Intended for
UPC Renewables Australia Pty Ltd

STUBBO SOLAR FARM AMENDMENT REPORT

Project name **Stubbo Solar Farm**
Project no. **318001132**
Recipient **UPC Renewables Australia Pty Ltd**
Document type **Amendment Report**
Version **V1**
Date **01/06/2021**
Prepared by **Belinda Sinclair / Taylor Hancock / Jon Williamson**
Checked by **Jon Williamson**
Approved by **Jon Williamson**
Description **Amendment Report for the Stubbo Solar Farm project.**

Figure 3-2 | Refinement of alternative access option at Blue Springs Road

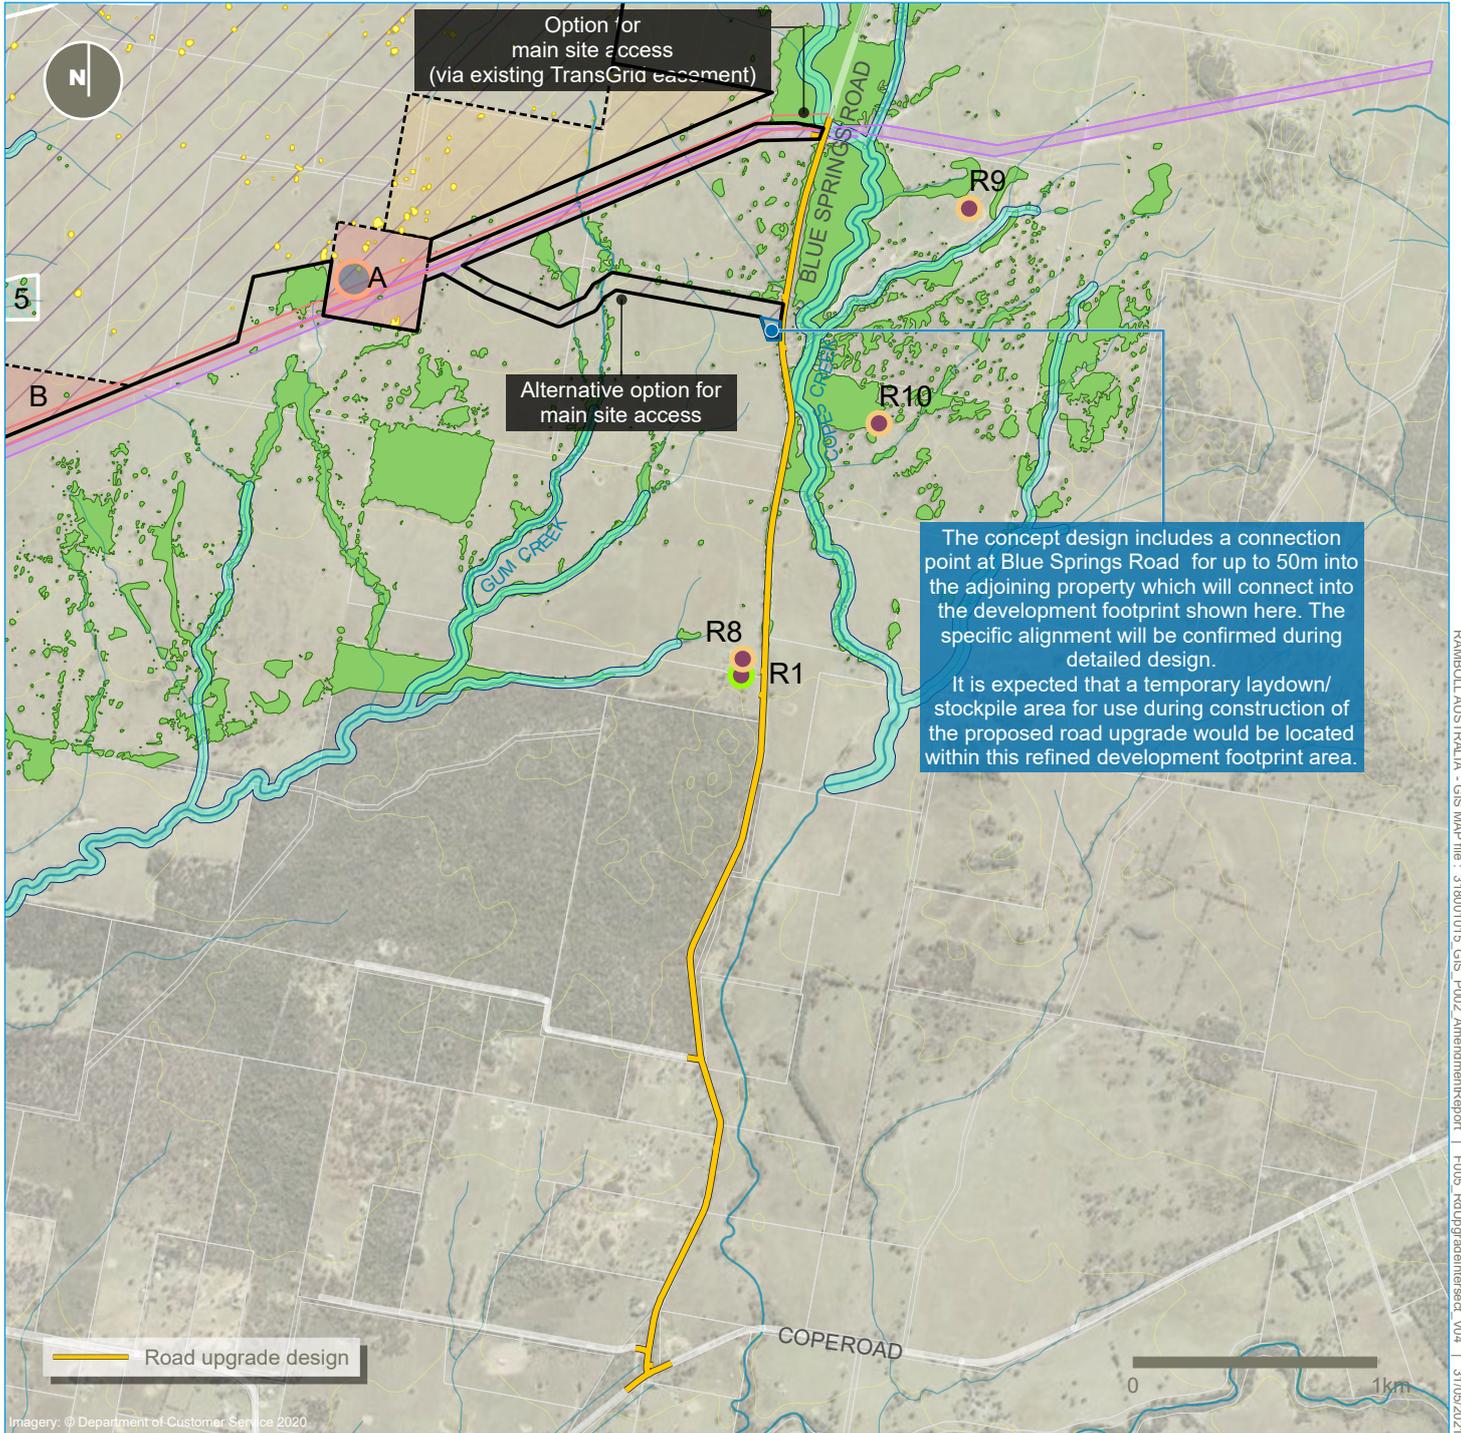
The proposed alternate access option was moved approximately 80 metres to the south to improve road safety and provide better sight distance for vehicles exiting the solar farm site and is shown in **Figure 3-2**.

Figure 3-3 | Blue Springs Road upgrade affected properties

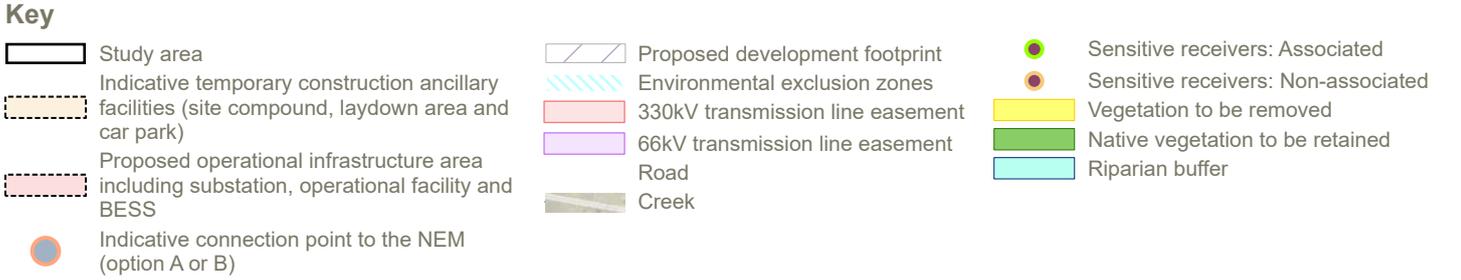
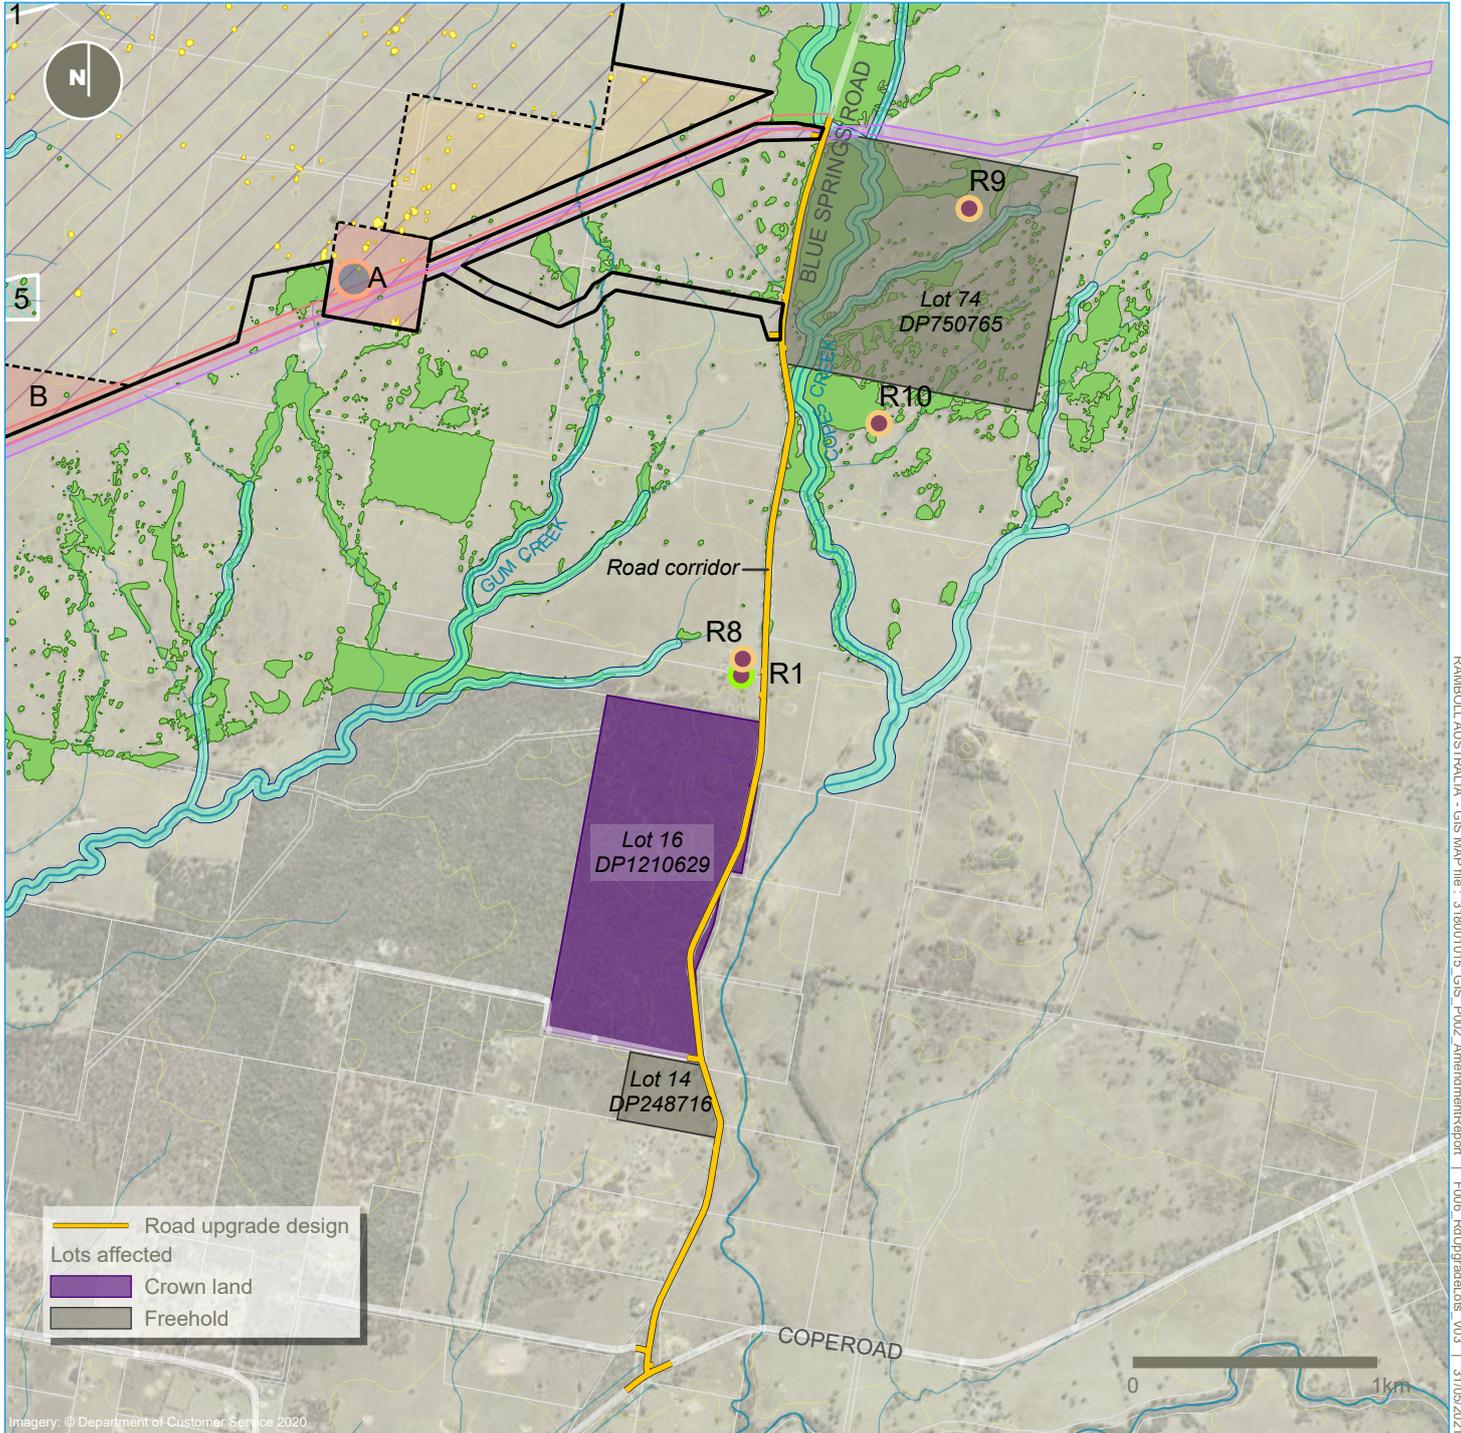
In addition to the road reserve (owned and operated by Mid-Western Regional Council), the cadastral validation only identified two freehold lots and part of the Cope State Forest as likely to be impacted by the proposed upgrade. These lots are shown on **Figure 3-3** and include the following:

- Lot 14/DP248716 (freehold)
- Lot 74/DP750765 (freehold)
- Lot 16/DP1210629 (Crown land managed by Forestry Corporation of NSW under Forestry Act 1916).

Figure 4-1 | Amended project overview

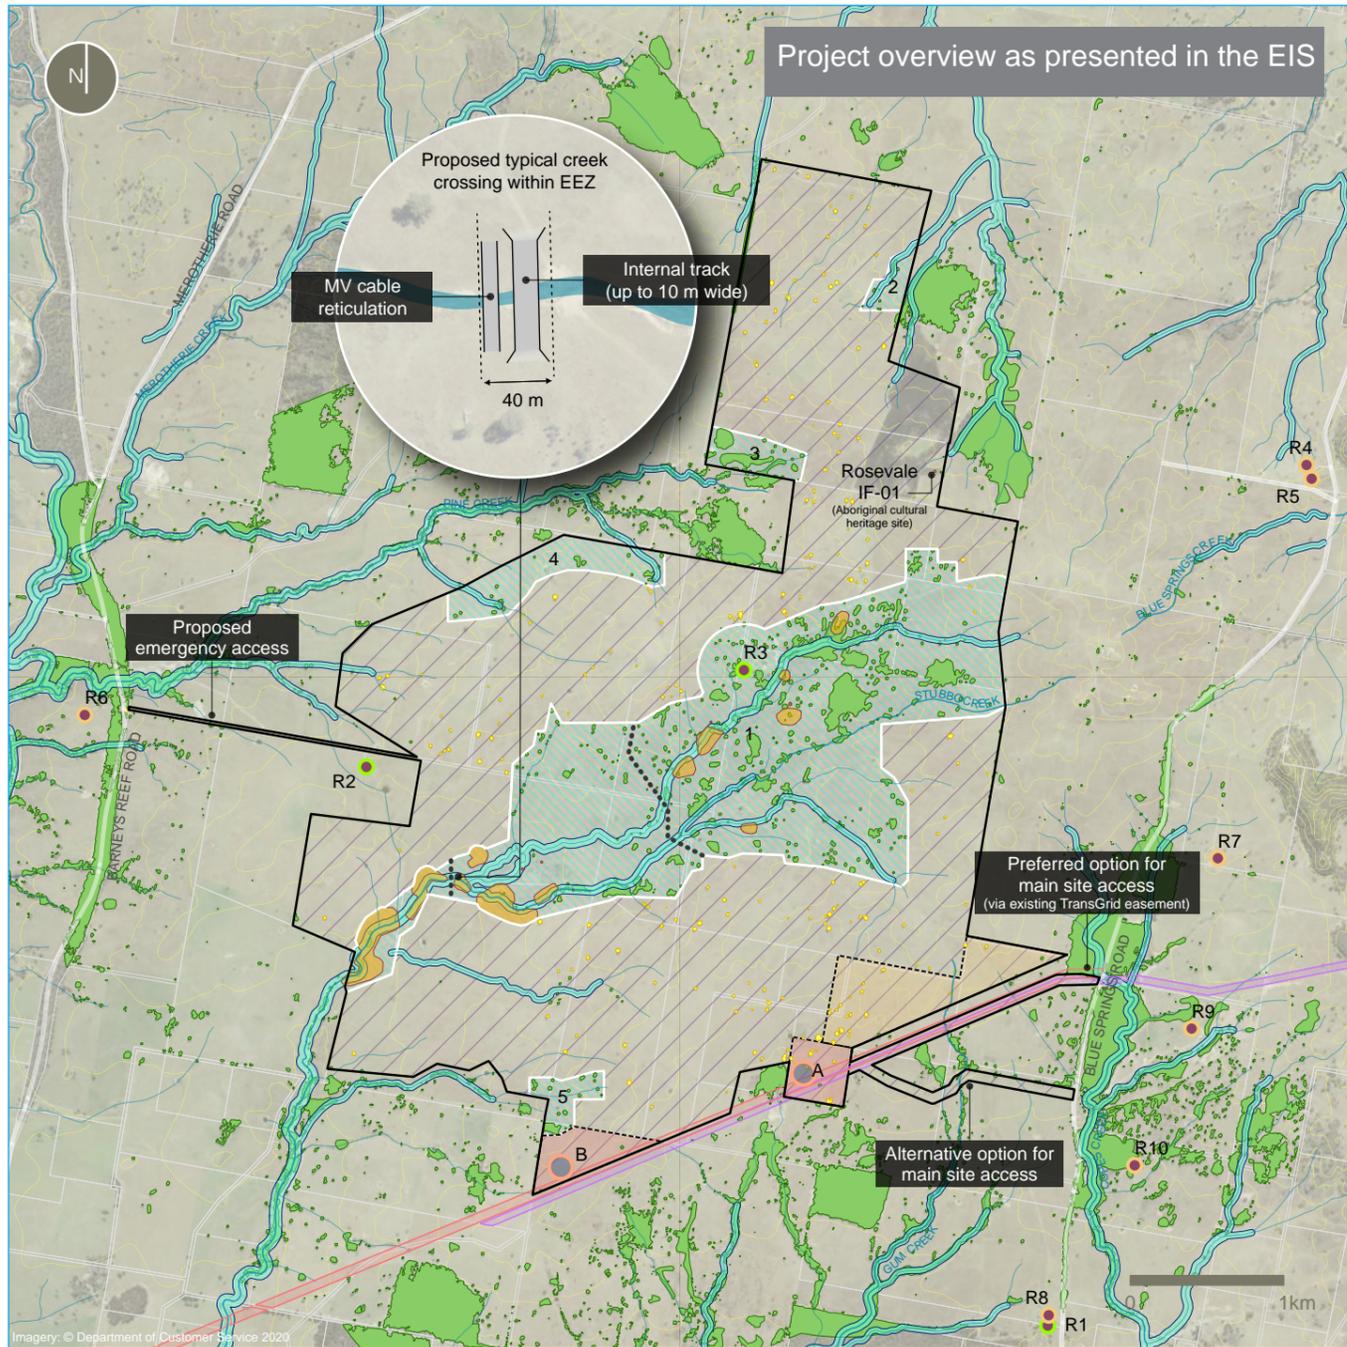
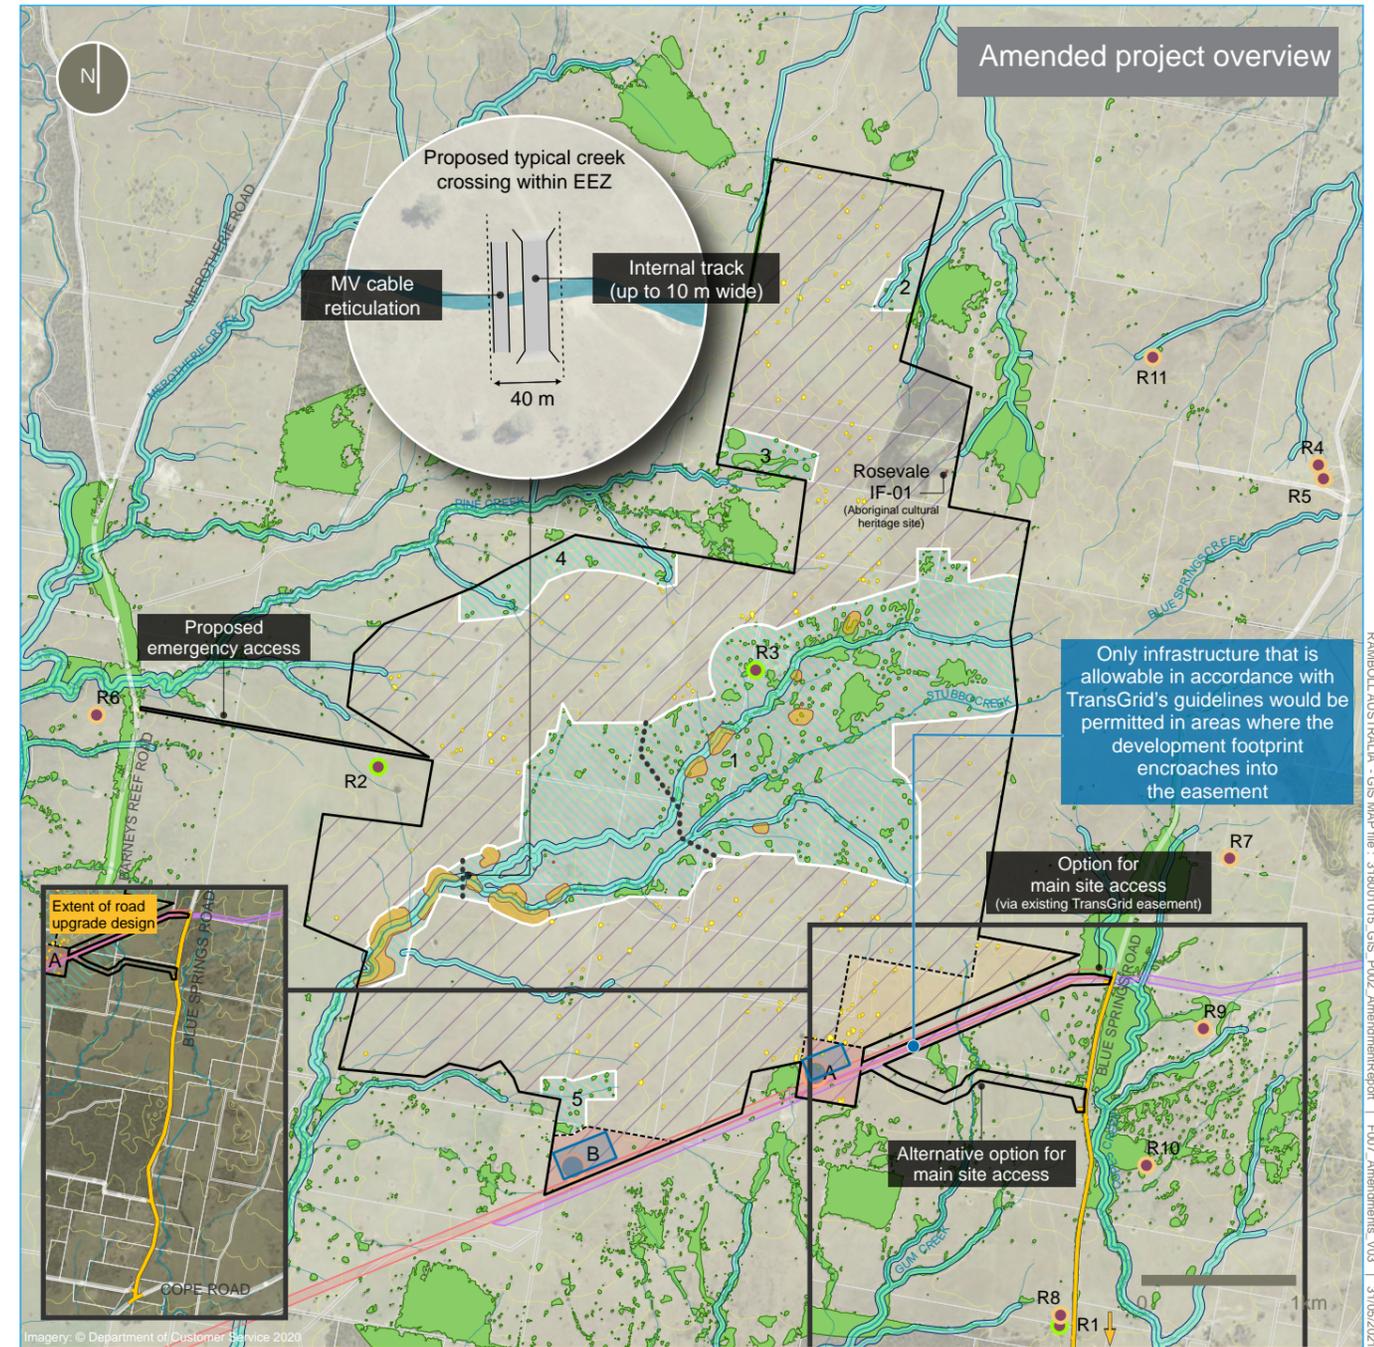
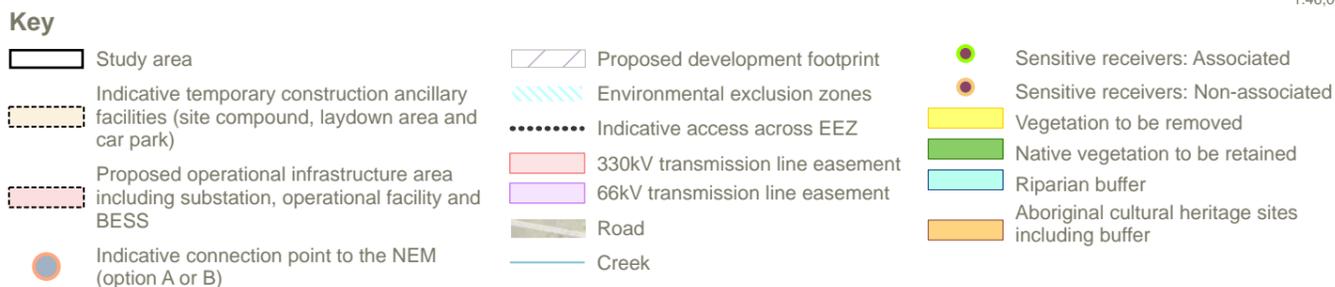
A summary of the amended project and how it has changed from the project as presented in the EIS, is provided in **Table 4-1** with a project overview figure is provided in **Figure 4-1**.
